Date Issued :	November 11, 2022	PCN Number :	512997
Reason for Change :	Change Supplier		
Description of Change :	Supplier Change : this notification is to inform you about a change of resin suppliers impacting the part(s) attached as per list. No changes will be made to product as part of this change.		
Reason for Short Notice :	Special Request		
Assessment of Change :	Reliability Test Report/s		
Planned Implementation Date :	February 01, 2023		
Sample Availability Date:	November 09, 2022		
Internal Molex Qualification Date :	November 09, 2022		
Last date to request Samples by Customer :	January 18, 2023		
Traceability Code Markings / Date :	Lot information on label

Change Overview

➤ Color difference

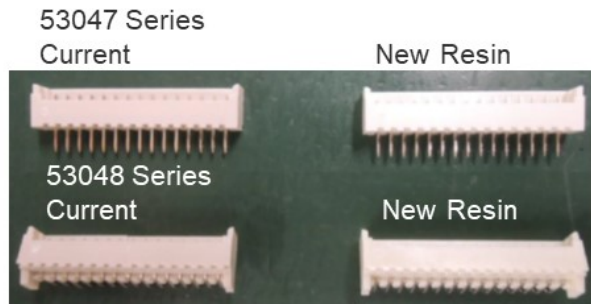
After changing the resin, the color will be slightly brighter.
